YALYALUP Mineral Sands Project

ENVIRONMENTAL REVIEW DOCUMENT- RESPONSE TO SUBMISSIONS, V4

EPA ASSESSMENT NO: 2141

Document Ref: DMS-YAL-ERD-RTS-004-V4

Q3 -2023
CONTOURS OF PREDICTED
DRAWDOWN IN LEEDERVILLE
AQUIFER DRY CONDITIONS
"BASE CASE" AND "SEPTEMBER
2020 CASE" YALYALUP
DEWATERING PREDICTIONS

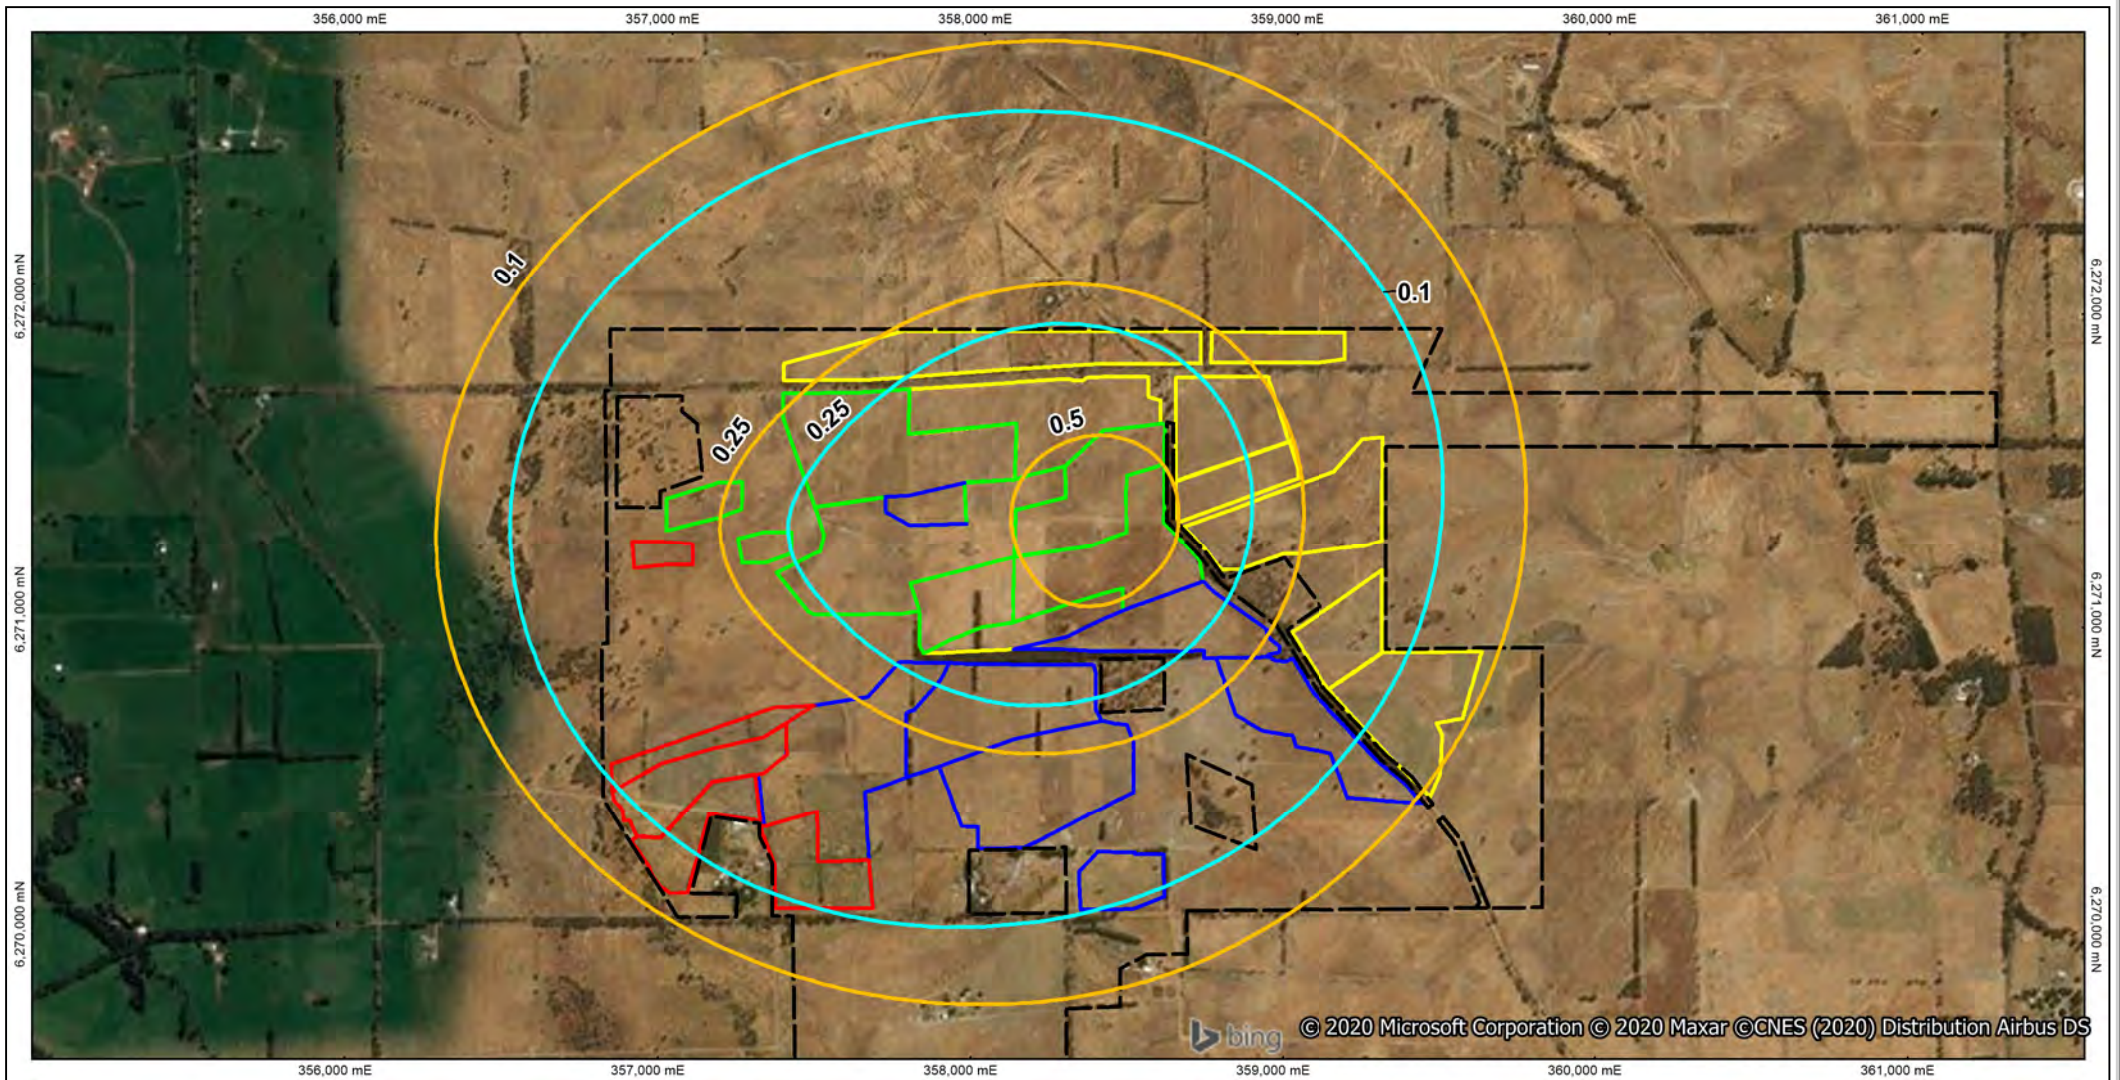
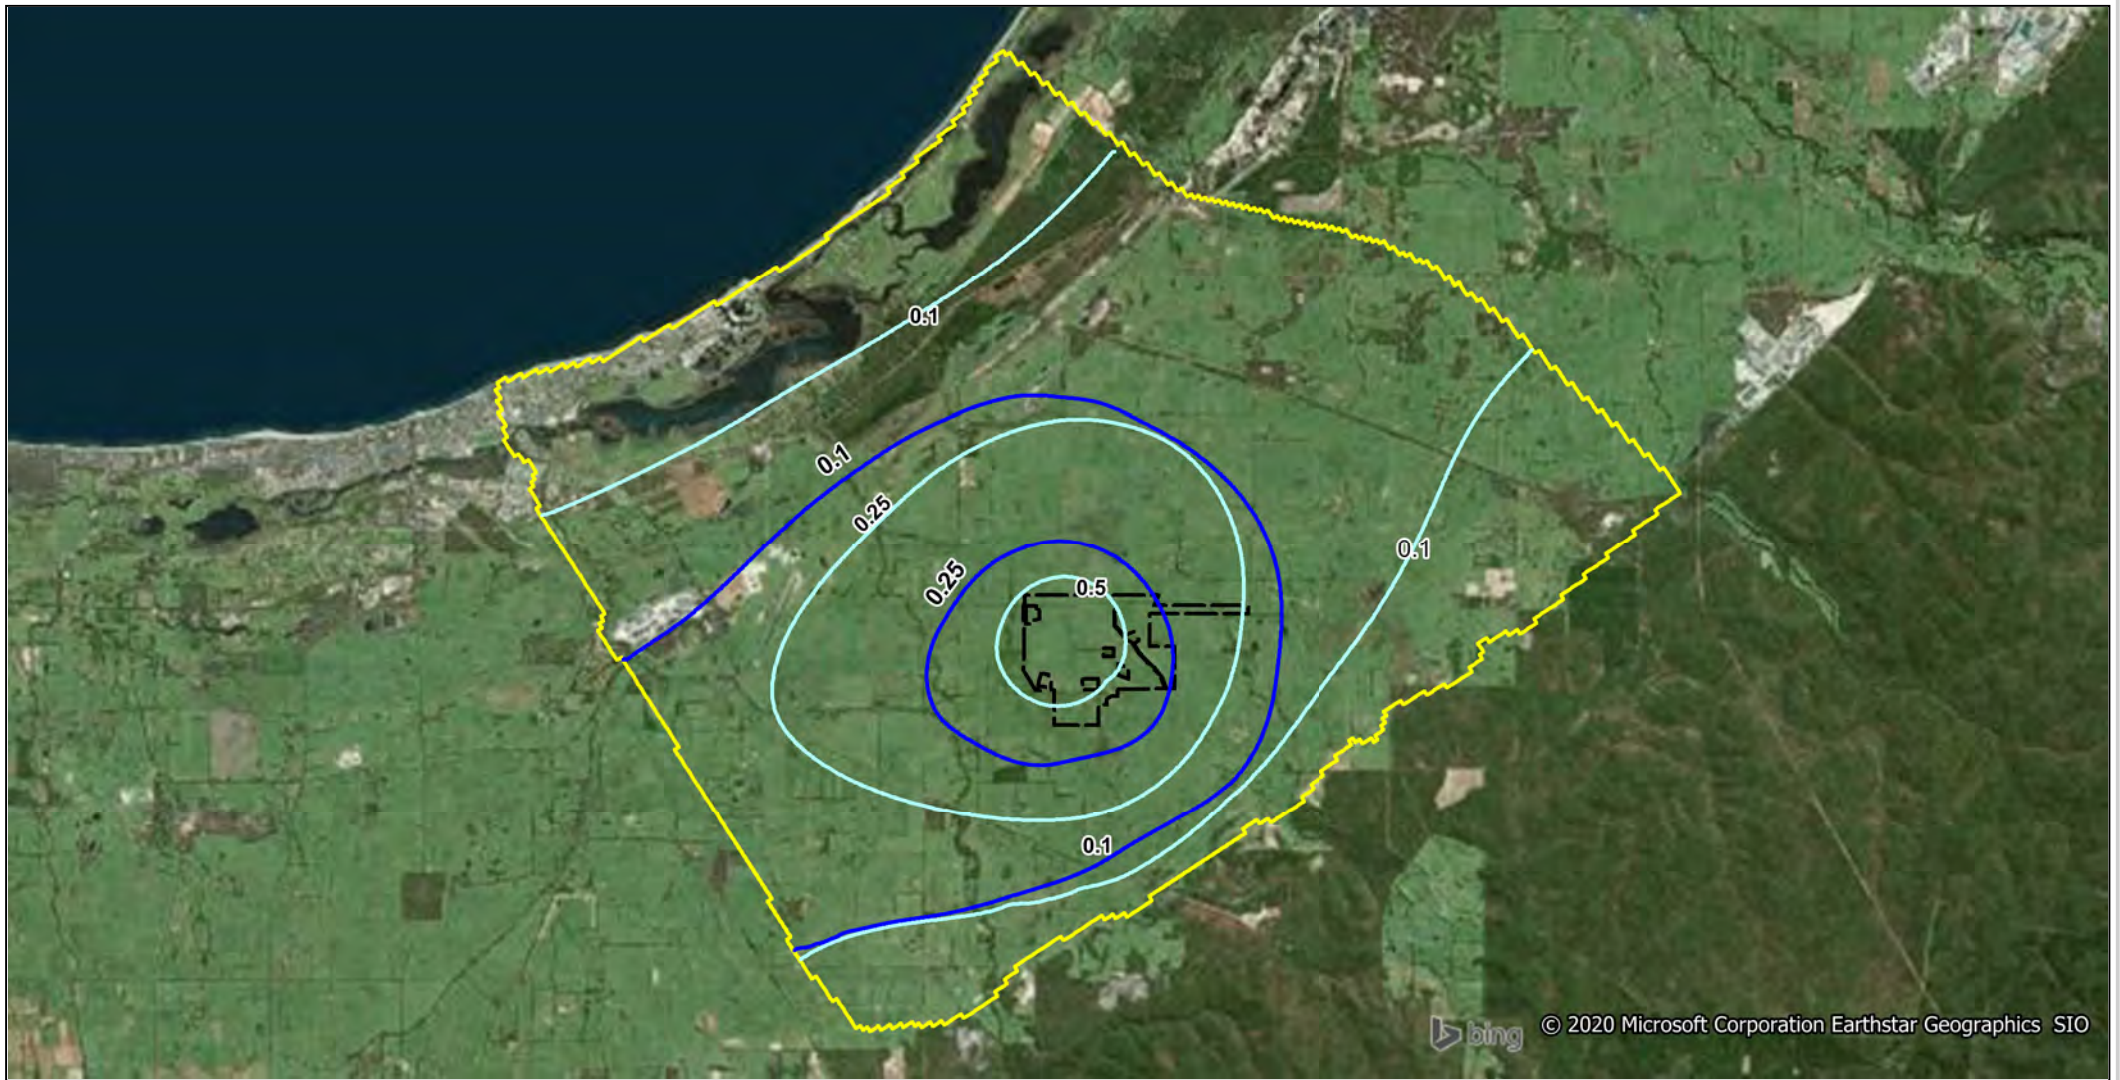
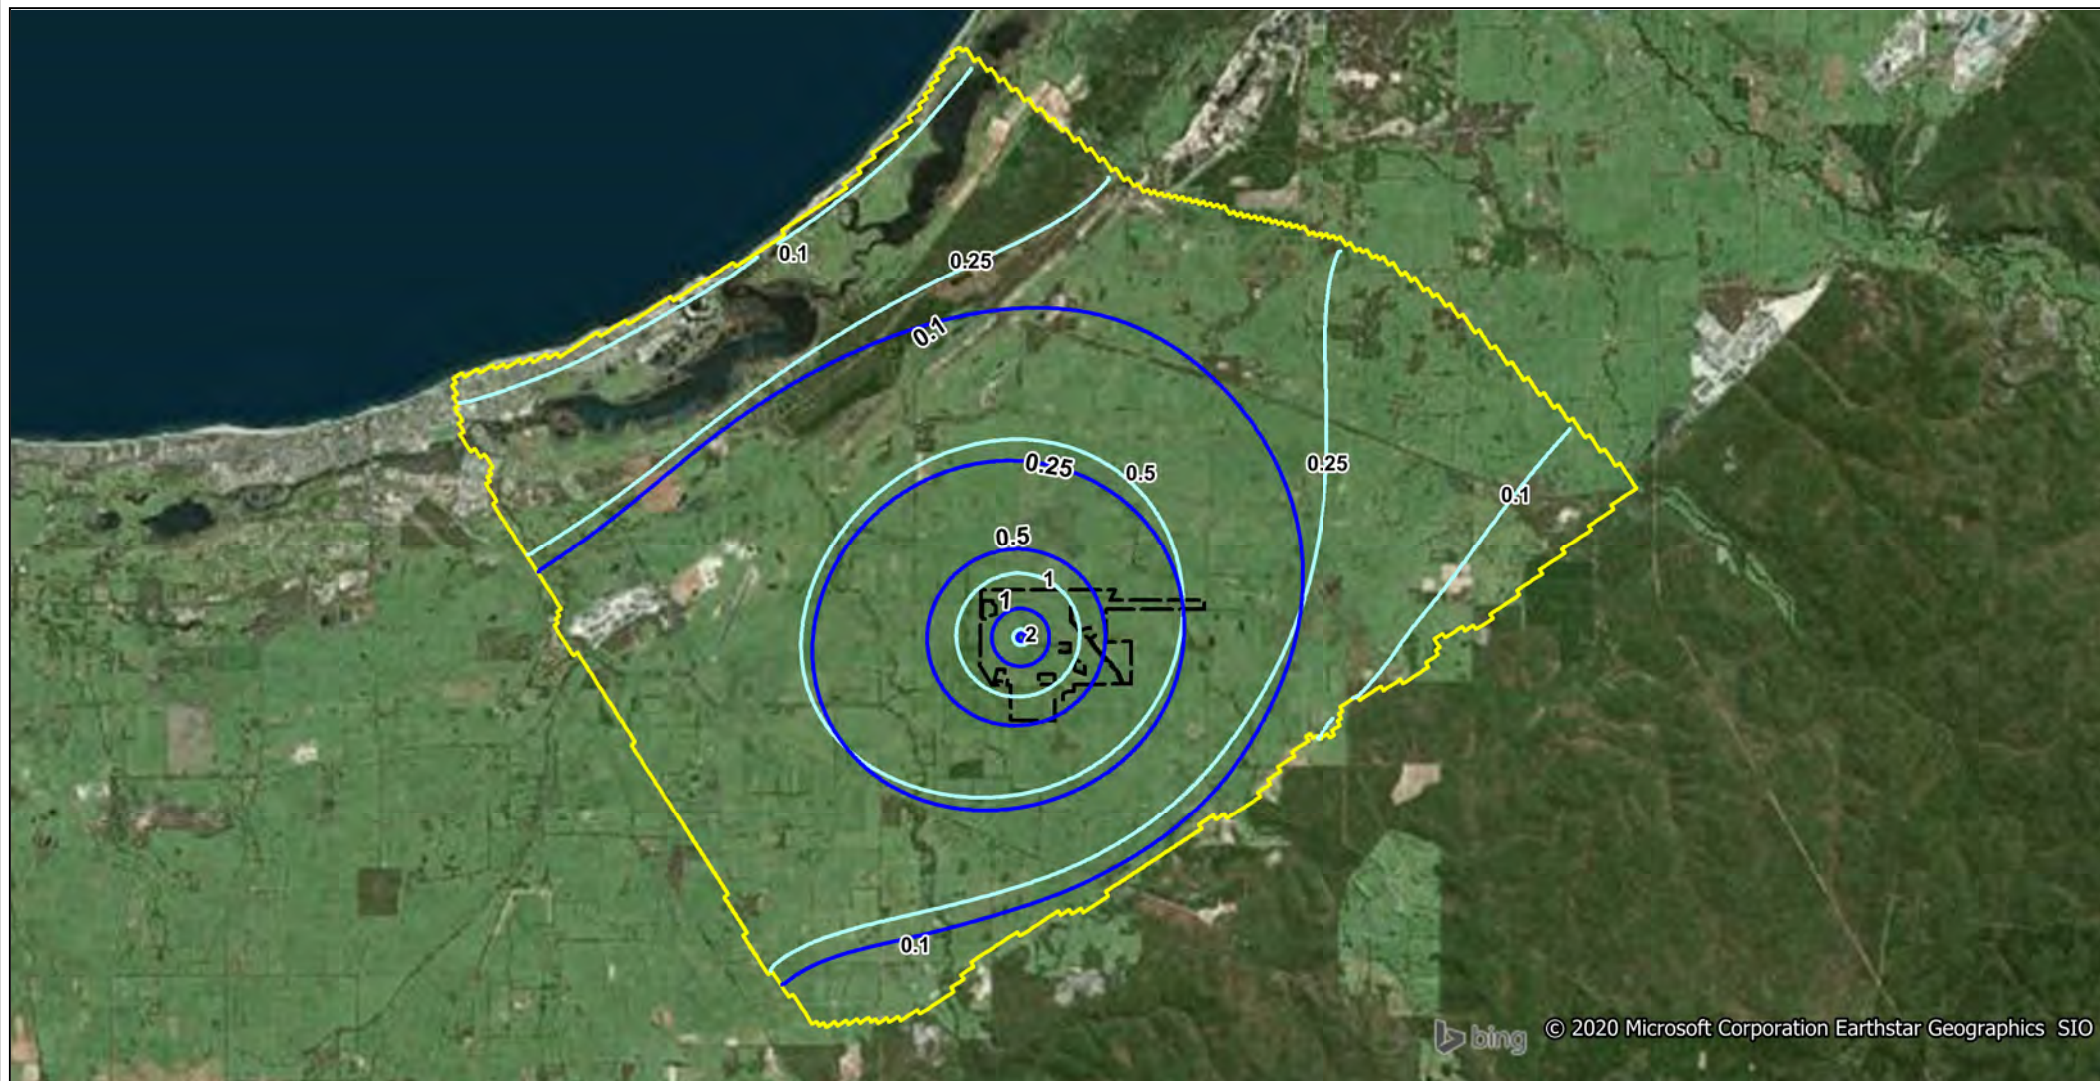
SUBMITTER	SUBMISSION AND/OR ISSUE	RESPONSE TO COMMENT
	<p>between the Leederville and Superficial aquifers (AQ2 2020a p. 21), clarification about the model sensitivity to hydraulic conductivities of the Leederville Formation is required.</p> <p>The Department also notes AQ2 (2020a, p. 50) groundwater modelling predicts groundwater levels will recover within the mining pits within approximately 18 months after the cessation of dewatering, with “no long-term (i.e. > 5 years) effects to the groundwater regime expected”. However as previously discussed in paragraph 7d, it is unclear what the associated level of uncertainty is for this prediction, and the range of possible recovery times under different model parameters (i.e. sensitivities).</p>	<p>As outlined, sensitivity analysis can be completed to assess the impact on model predictions. However, without re-calibration, as completed for the uncertainty case, the predictions are completed with an uncalibrated model. While predictions with an uncalibrated model may illustrate the model sensitivity to a parameter, the change on its own, does not illustrate the impact using a calibrated model and provides no more confidence in model outcomes.</p> <p>In the case of this model, the use of a calibrated model is particularly important due to the interactions between the aquifer properties and the assigned recharge. With the current model a decrease in any aquifer parameters will require a reduction in the assigned recharge to maintain model calibration. If any predictions were completed with an uncalibrated model, the model would tend to under or over predict impacts (i.e. drawdowns).</p> <p>No changes to aquifer specific yield were made to the Leederville and Yarragadee aquifers as part of the uncertainty analysis as these aquifers remain confined during all simulations and aquifer specific yield is not a key aquifer parameter for these aquifers.</p> <p>For the Leederville aquifer some of the model adopted values do not cover the higher end of the range of horizontal and vertical hydraulic conductivity (Tables 1 and 3). To address this, AQ2 have re-run the model (the “September 2020 Case”) with the adjustments shown in Tables 1 and 3 (shaded). The aquifer parameter adjustments were made to the Leederville aquifer only. For the September 2020 Case the calibration data set and the prediction models (assuming dry conditions) have been run to produce the measured drawdown as shown in Figures 1 to 4. No re-calibration of the September 2020 Case model has been completed.</p> <p>Figures 1 and 2 show drawdown for the dewatering cases for the Superficial and the Leederville aquifers for the Base Case and the September 2020</p>

SUBMITTER	SUBMISSION AND/OR ISSUE	RESPONSE TO COMMENT
		<p>Case. The Base Case and September 2020 Case predictions show comparable drawdown (i.e. the changes in aquifer parameters in the Leederville aquifer do not appreciably increase the extent of drawdown). Figures 3 and 4 show the predicted drawdown for the Water Supply Only Case. The predicted drawdown in the Leederville and Yarragadee aquifers for the September 2020 Case at the end of mining are less than those predicted for the Base Case. Similar to the previous predictions, there is no predicted drawdown in the Superficial aquifer due to the proposed water supply pumping and the changes in adopted aquifer parameters.</p> <p>The current model set up is conservative with respect to aquifer parameters assigned to the Yarragadee water supply aquifer however, it is possible that there could be further ranges of aquifers parameters that could be investigated as part of future work. The model set up of this aquifer and potential uncertainties will be further investigated as part as proposed work (as outlined in Section 9.12 of the Hydrogeological report).</p> <p>Fieldwork to drill and construct a Yarragadee production bore and undertake aquifer tests is scheduled after the environmental approvals for the Yalyalup mine site are received from DWER. A nest of four monitoring bores, at a nearby location of the Yarragadee production bore, are proposed to be drilled and constructed separately into the Superficial, shallow Leederville (Mowen), deep Leederville (Vasse) and Yarragadee aquifers, to allow monitoring of water level changes in each aquifer during the test pumping of the Yarragadee production bore and during future mining operations (to determine if there is any short-term and long-term vertical leakage between aquifers). The groundwater flow model will be updated for H3 level reporting to support a DWER 5C groundwater licence application to include the site-specific data for the Leederville (Vasse member) and Yarragadee aquifer (refer to more comments below under DAWE comment 1d).</p>
